BRIEF DESCRIPTION OF REQUEST
Amend an approved DRB Site Plan for Building Permit to modify the site layout.

ADMINISTRATIVE AMENDMENT TO SITE PLAN FOR BUILDING PERMIT

CARLISLE CROSSING
2100 CARLISLE BLVD NE
ALBUQUERQUE, NEW MEXICO

SITE PLAN FOR BUILDING PERMIT

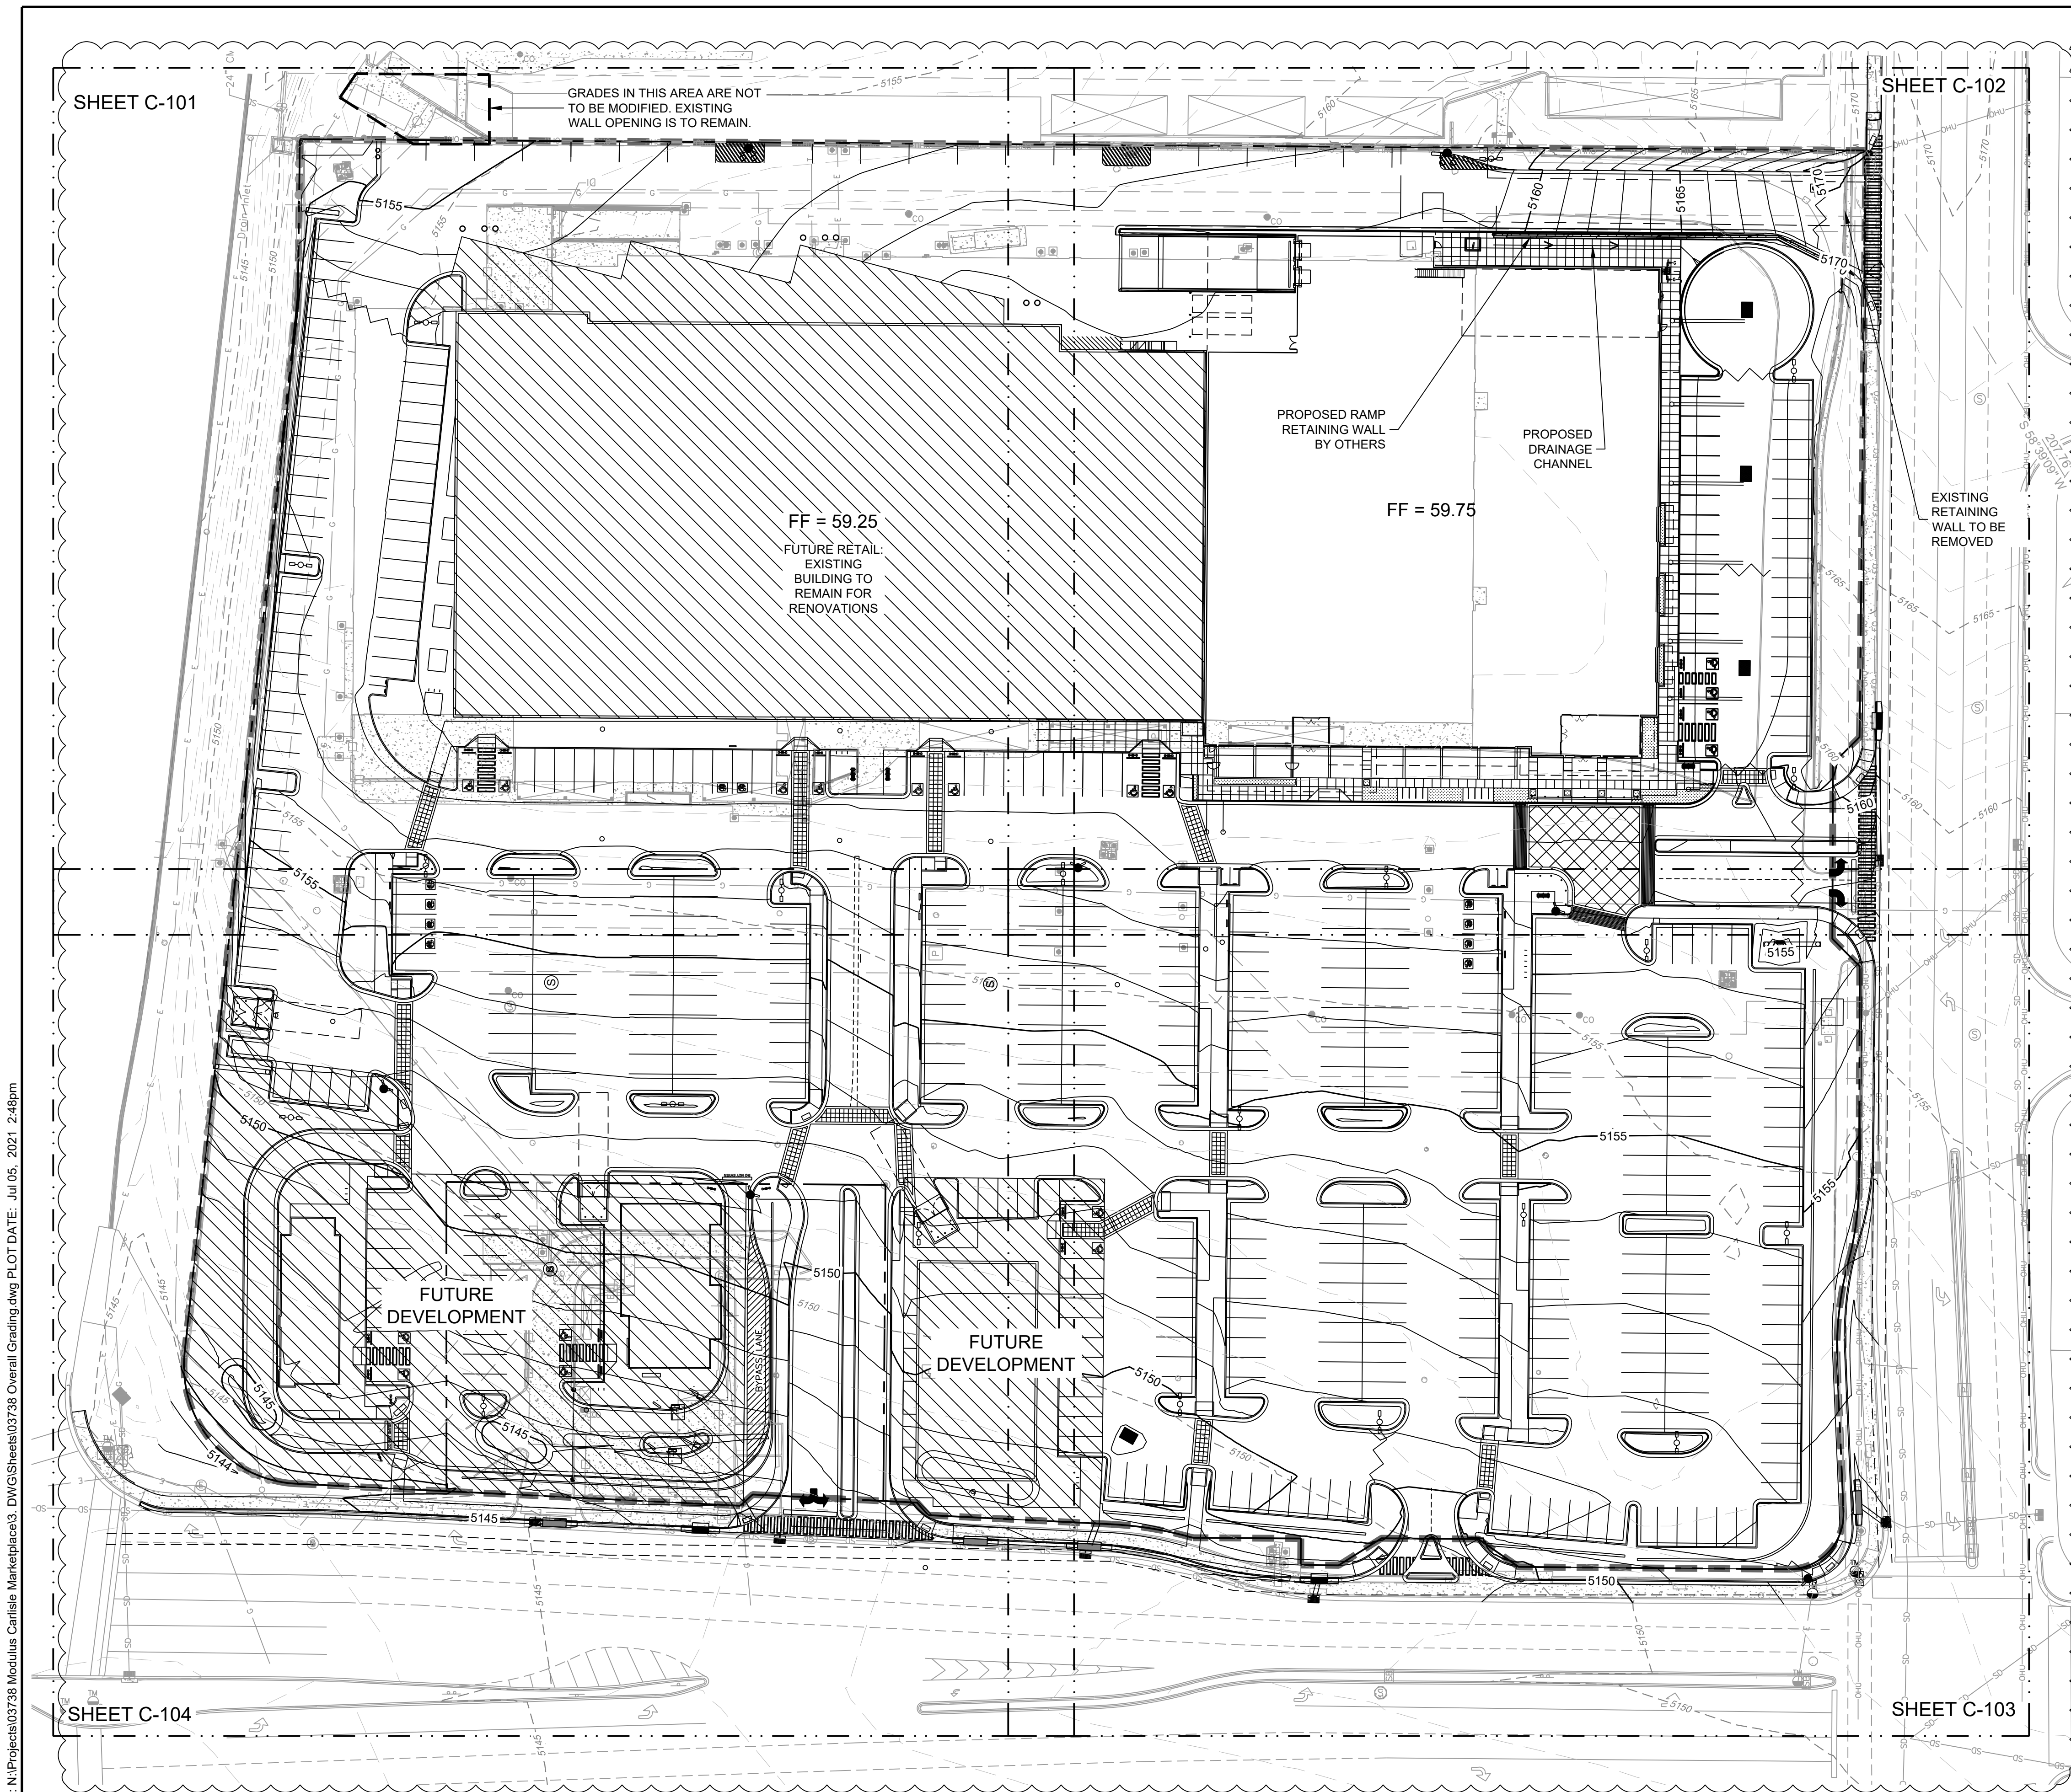
Our submittal includes the original approved plans, the amended Site Development Plan, amended Landscaping Plan, amended Grading Plan and an amended Utility Plan. The minor changes are

listed below. Changes to the overall Site Development Plan package are identified in the AA drawings via bubbled areas.

Site Development Plan:

1. The existing building pad site to the south (P3 – 5,500 SF) has been removed.
2. The existing Burger King Site configuration has been modified.
3. The SE corner of the parking lot got changed to a roundabout area.
4. The exterior of the building currently has 4 docking areas and the new proposed Site Plan removes 3 of the docks.
5. Parking Calculation – We have not created a deficiency in the parking requirements and that is demonstrated on the Site Plan (Site Data Table). We are providing more parking spaces and handicapped spaces than the original approval.

SHEET TITLE: GRADING PLAN 1

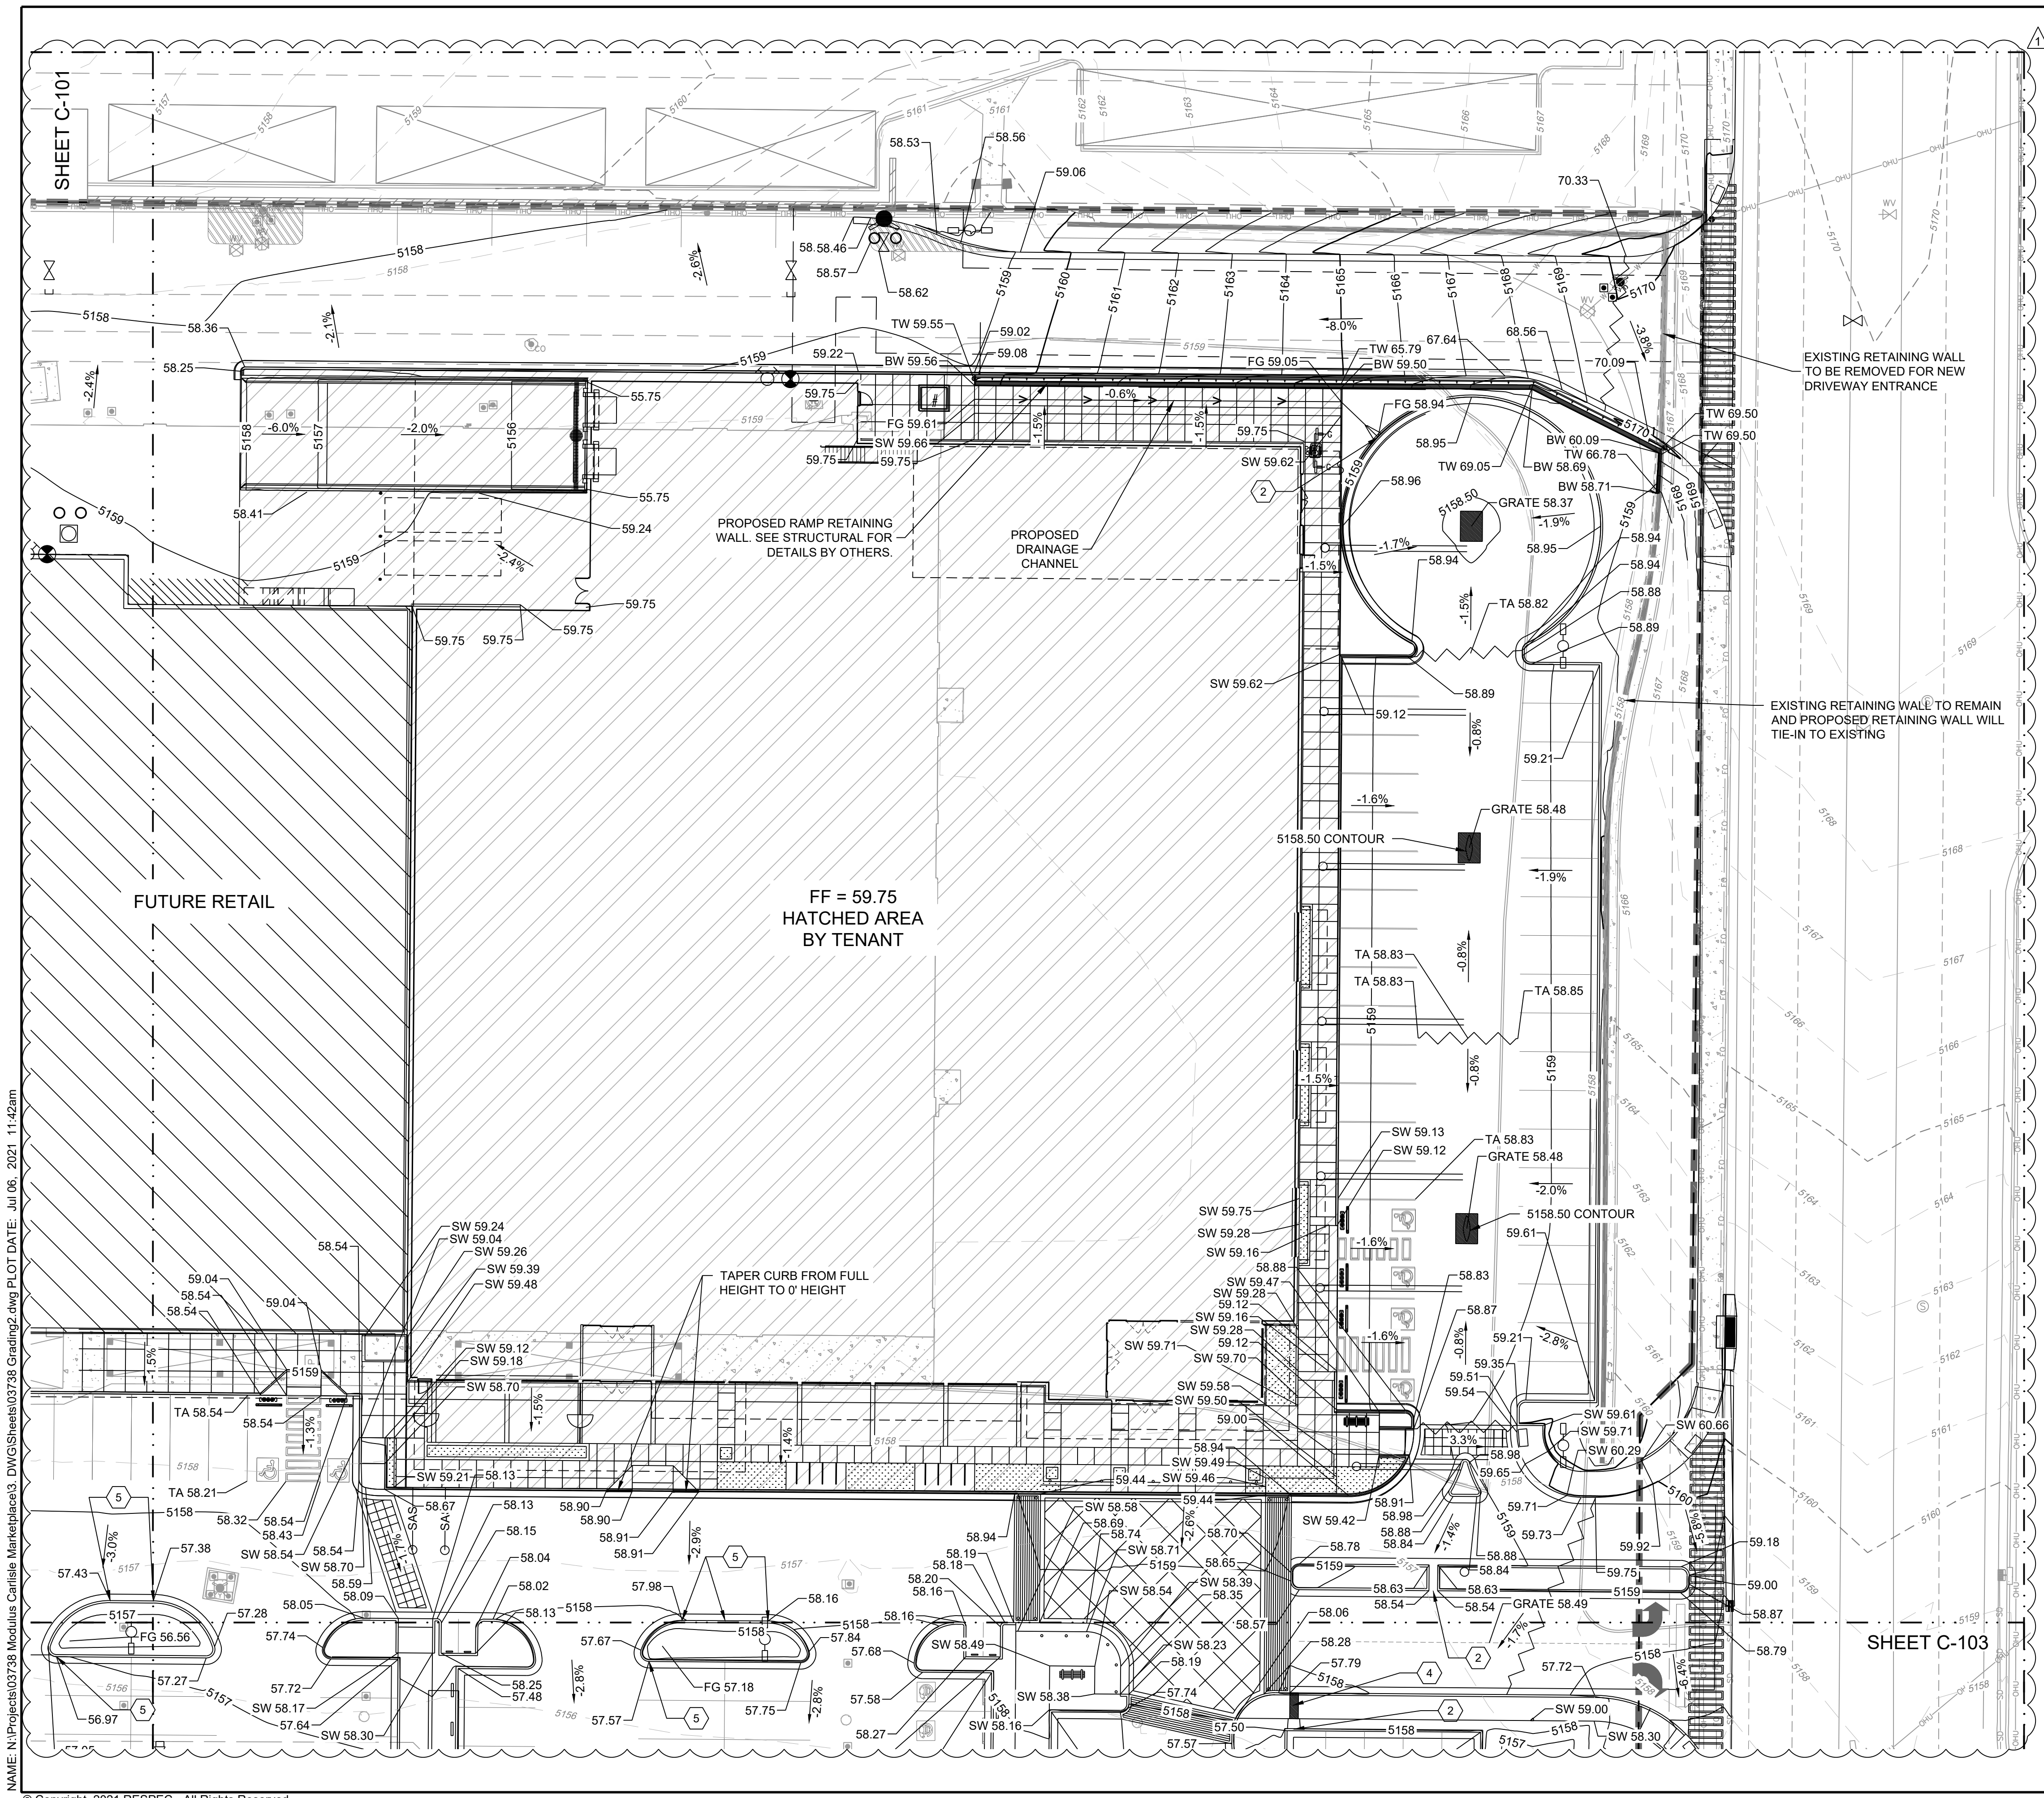
Grading Plan:

1. The Grading Plan has been modified to accommodate the changes to the Site Plan. All changes meet the IDO and the DPM standards.

DESIGNED DRAWN CHECKED DATE 7.05.2021	BE BE JS JS DATE 7.05.2021	RESPEC 6971 JEFFERSON STREET SUITE 101 ALBUQUERQUE, NM 87105 WWW.RESPEC.COM 505.253.9718 UPDATED SITE PLAN (5 JULY 2021)	REVISION NO. DATE DESCRIPTION
			PROJECT NAME: CARLISLE CROSSING
SHEET TITLE: UTILITY PLAN			
SHEET NUMBER: C-105

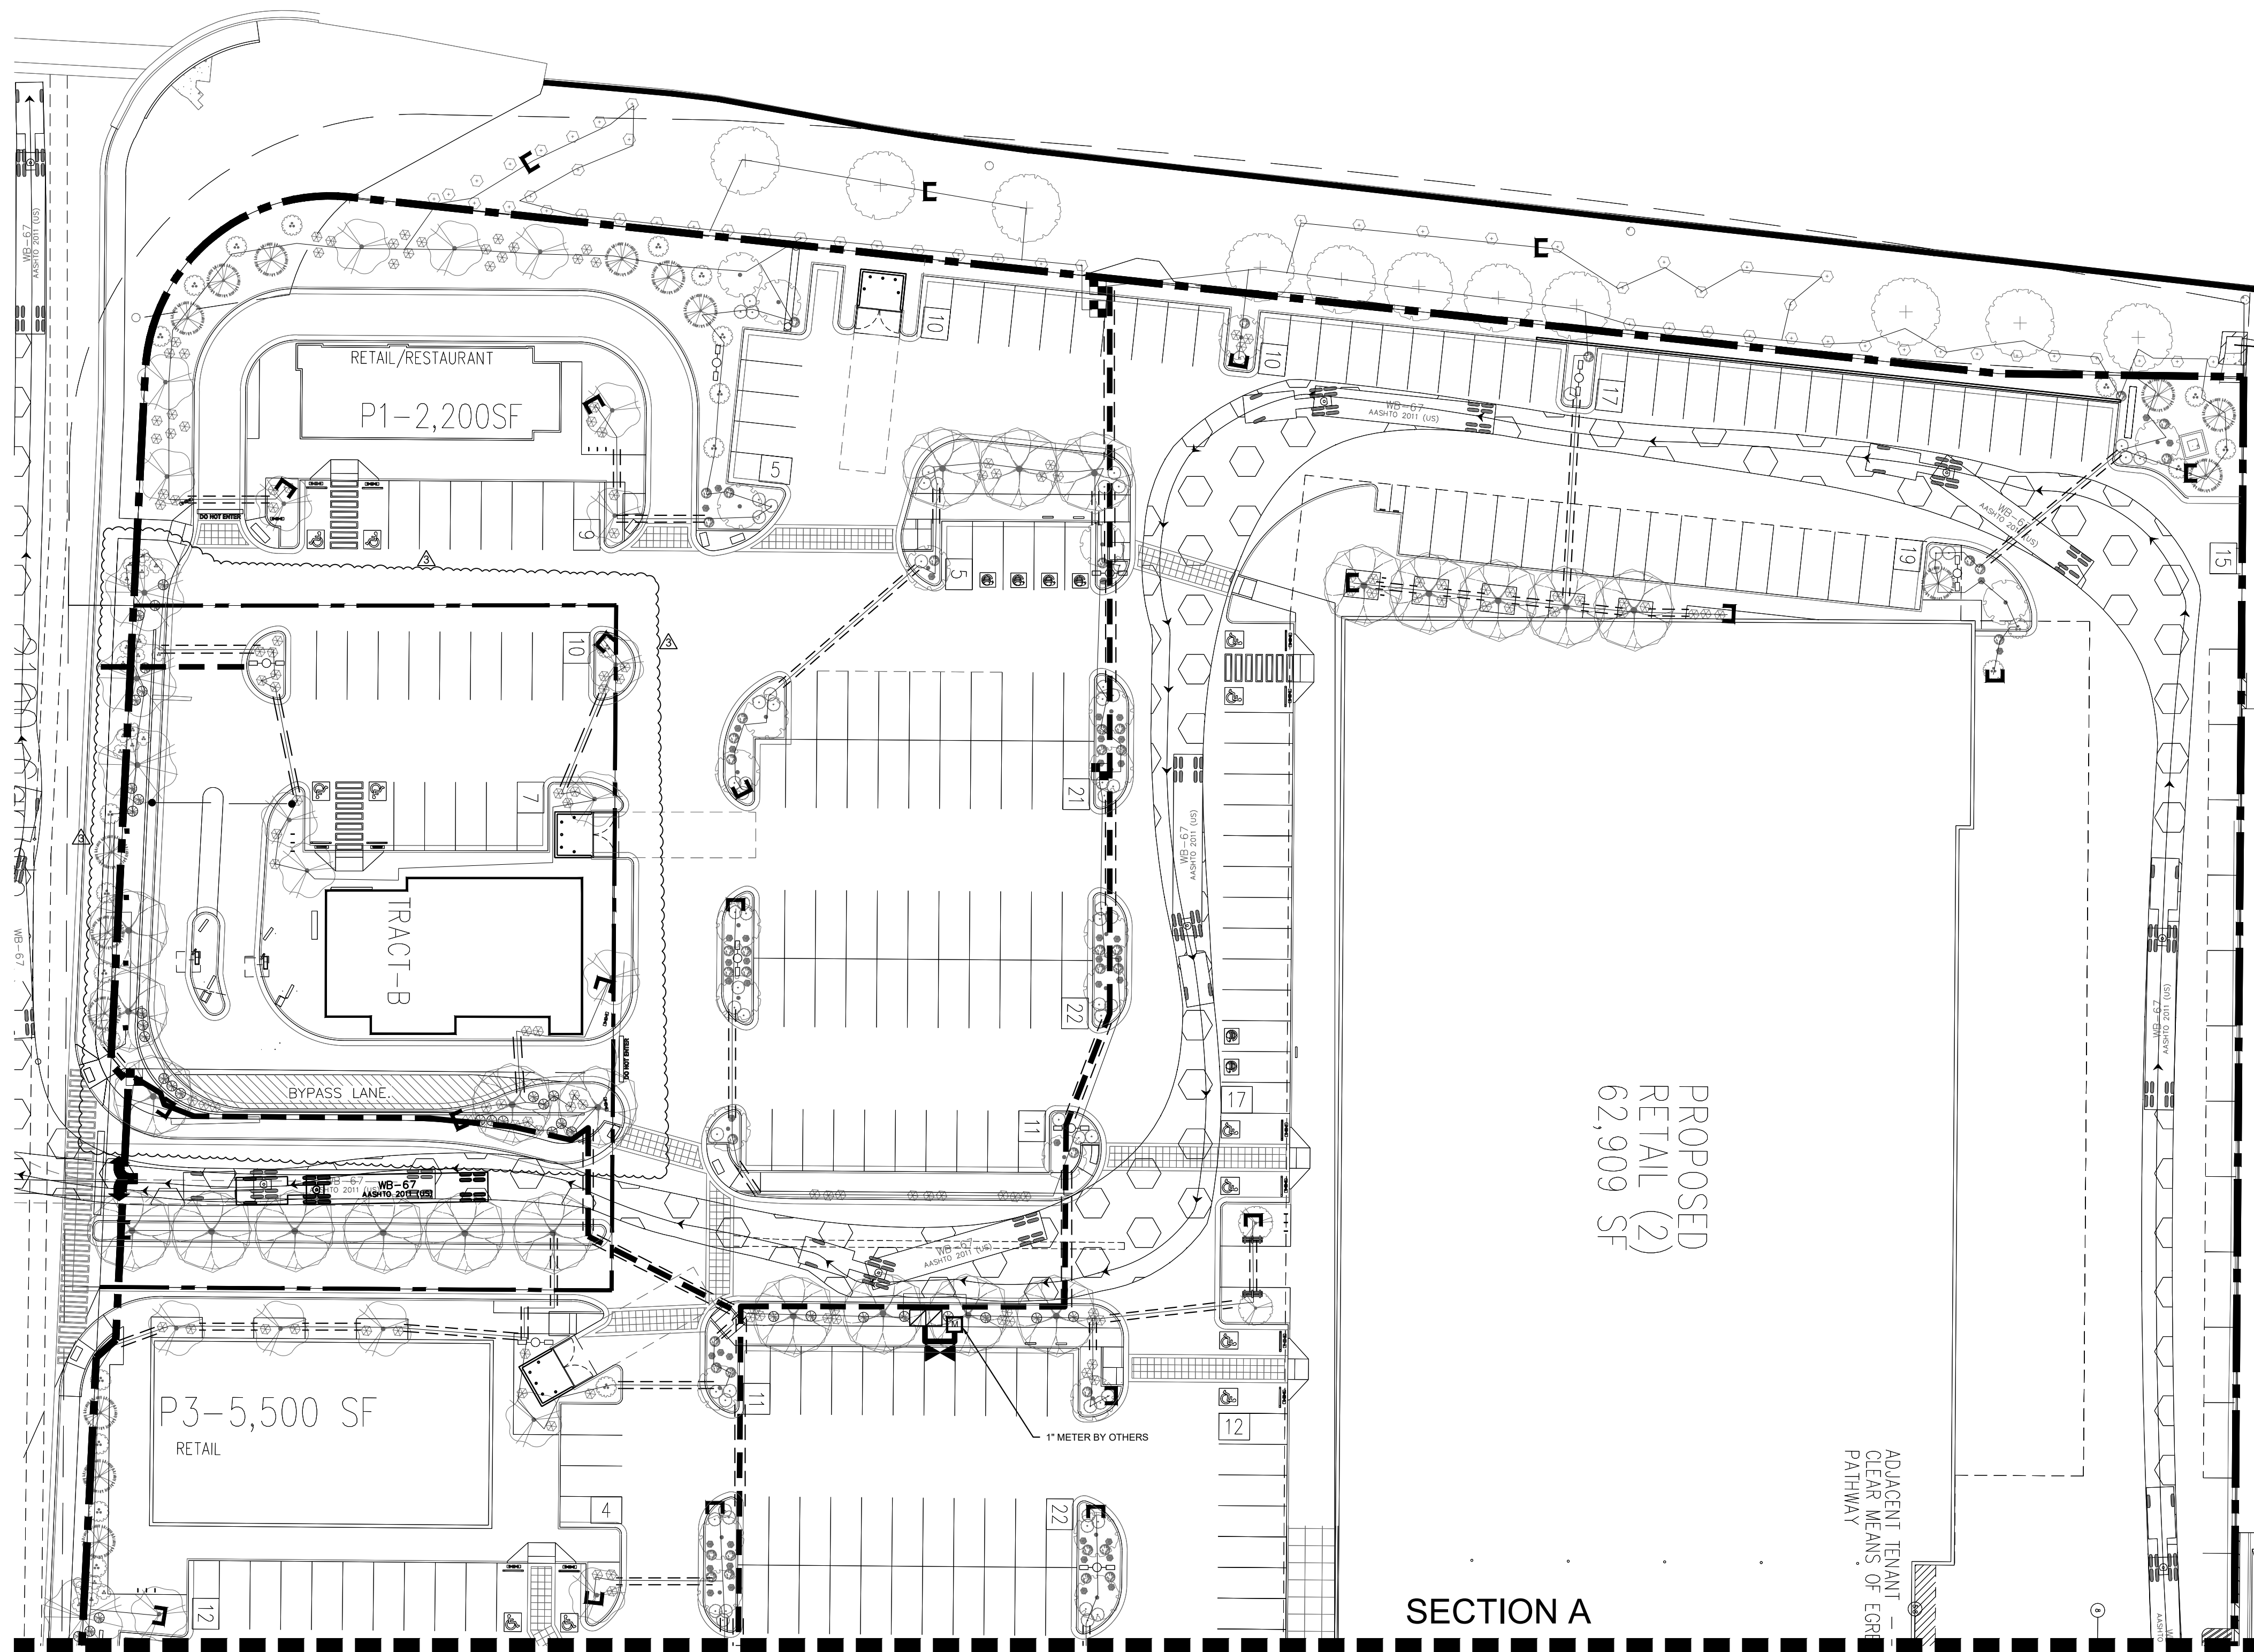
Utility Plan:

1. The Utility Plan has been modified to accommodate the changes to the Site Plan. All changes meet the IDO and the DPM standards.
